Official Transcript of Proceedings
NUCLEAR REGULATORY COMMISSION

Title: Advisory Committee on Reactor Safeguards
APWR Subcommittee - Open Session

Date: Friday, April 22, 2011

Chapter 11: Radioactive Waste Management Systems

LWMS Process Flow Diagram (Chemical Drain and Detergent Drain Subsystems)

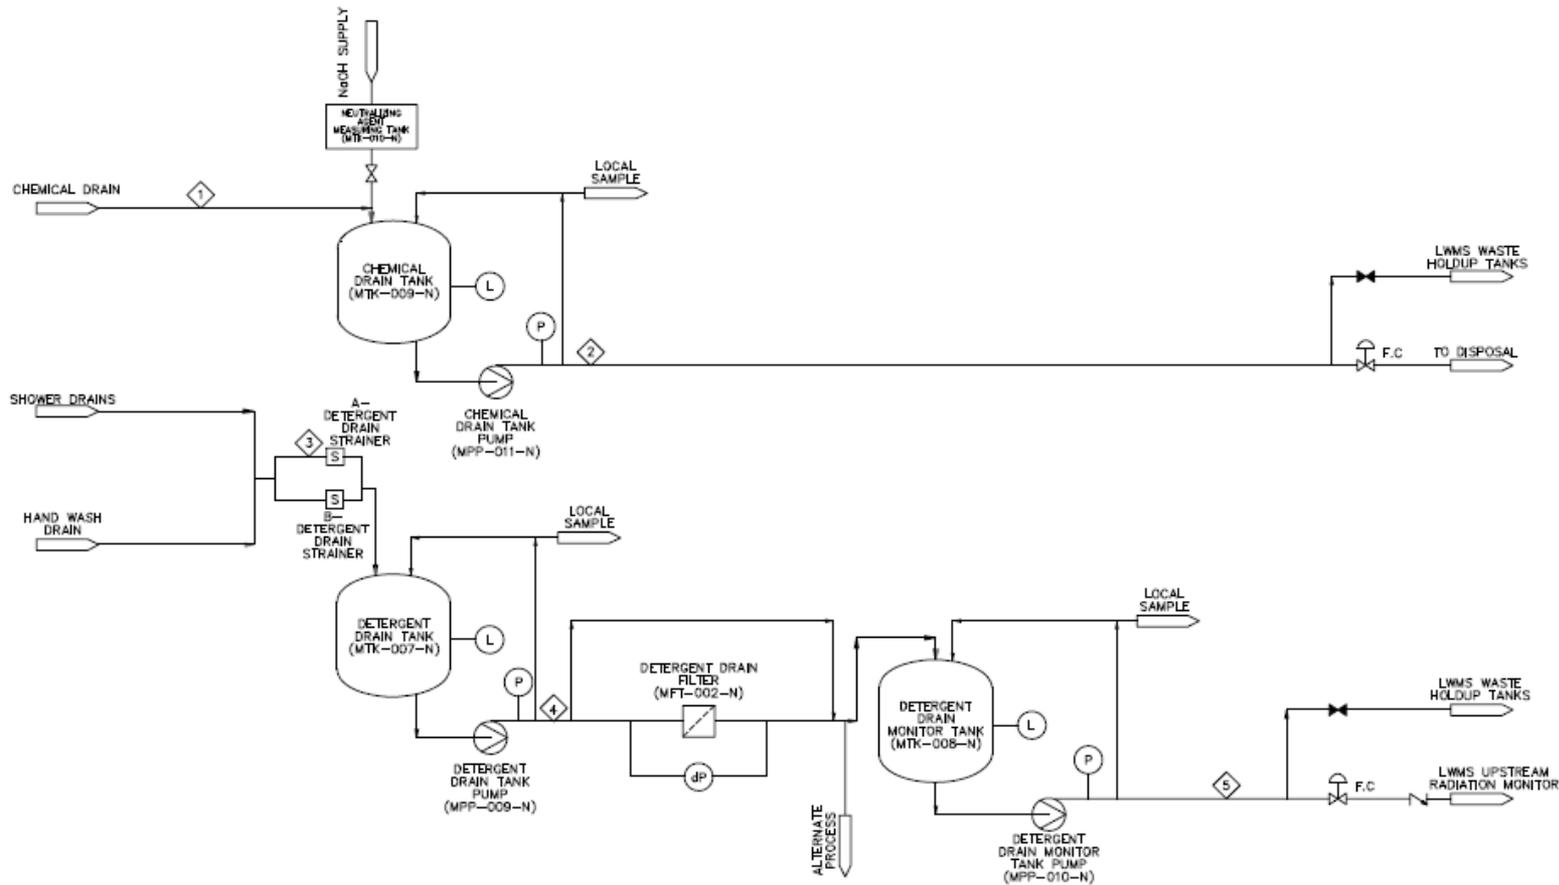
3 And on the bottom we show the detergent
4 drain subsystem. We have one collection tank going
5 through a filter. Collect it, sample it. And then we
6 can either discharge it through the discharge header
7 and - or go through the waste holdup tank for further
8 processing.

9 Let me clarify one thing is that for the
10 liquid system, there is only one discharge line going
11 out the building. There's no other line for that.

GWMS Process Flow Diagram

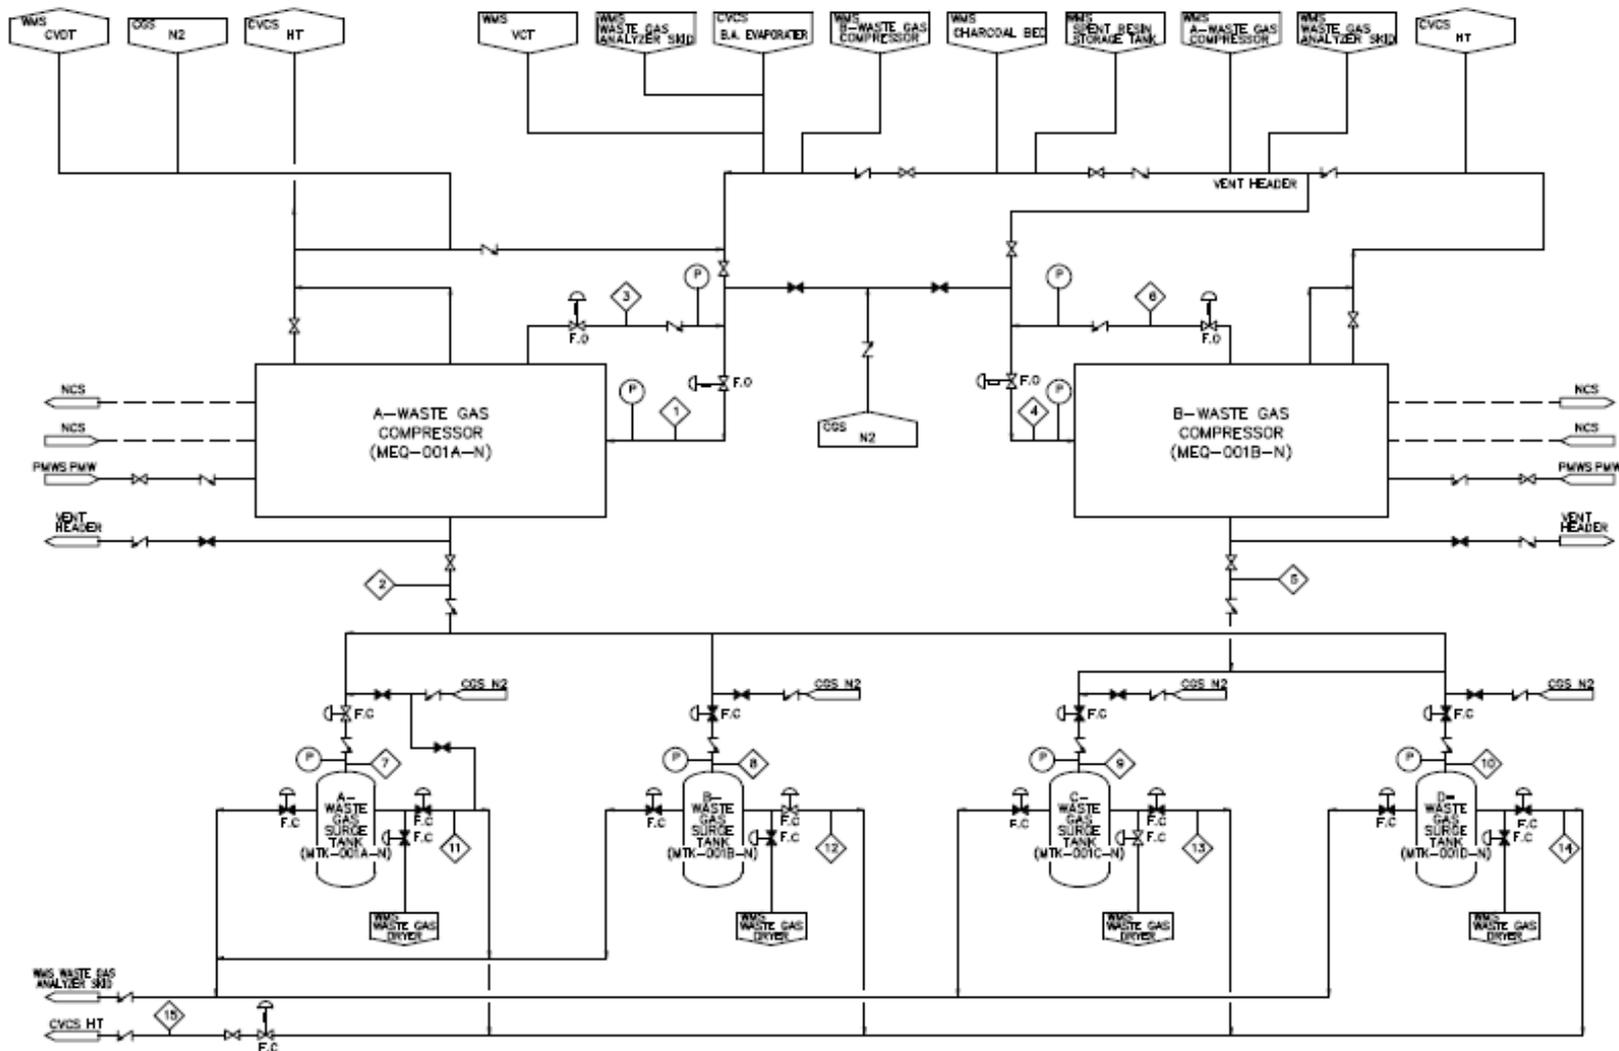
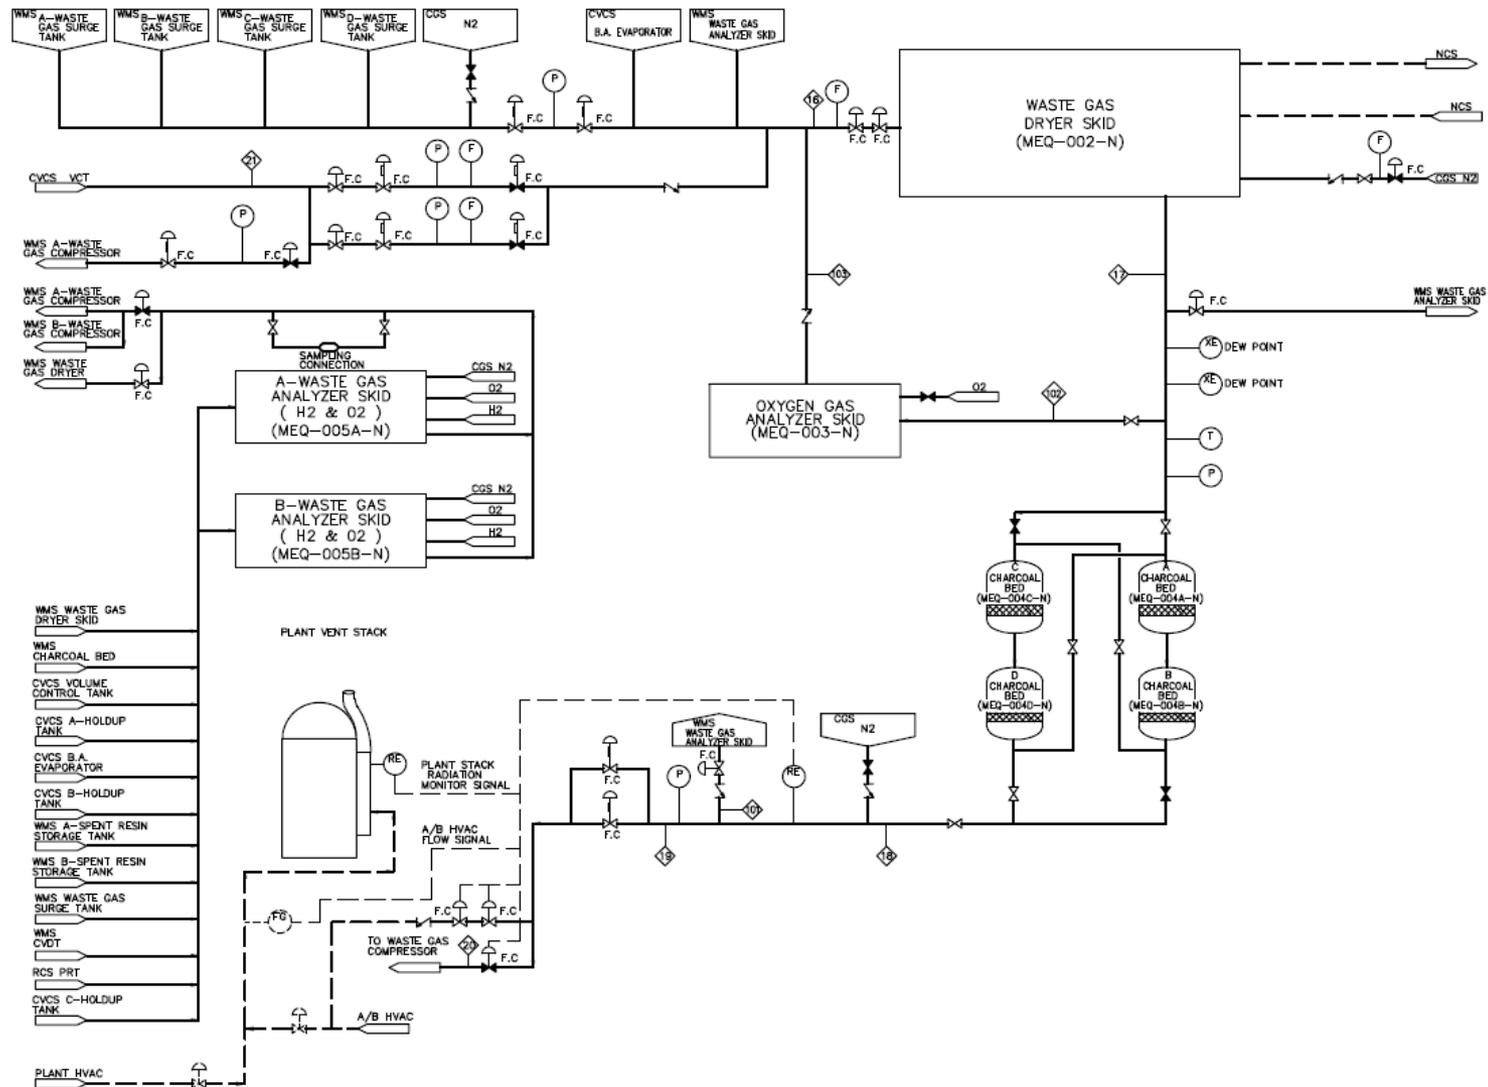
20 MEMBER RYAN: Hang on. It looks like that
21 all the sources that go into the tanks can either all
22 go into A or B; is that correct?

18 And at the bottom left of the screen, I
19 show the radioactive waste gas going into the vent
20 header, the auxiliary building vent header, the HVAC
21 header, before it go into the plant stack.

8 MEMBER BROWN: Excuse me just a minute.
9 Correct me if I'm wrong. It seems all these, the vent
10 stack is common for all the standard HVAC, as well as
11 the gaseous waste discharge as well? And they all
12 come together in one point like that.

21 The reason I ask that, at the plant that
22 I was mentioning, it didn't. I don't need to go into
23 details of how we did it, but they were not directly
24 processed through anything that you show on this
25 slide. So, I was curious where those lines actually

7 MR. TSANG: I'd like to take that question
8 back.
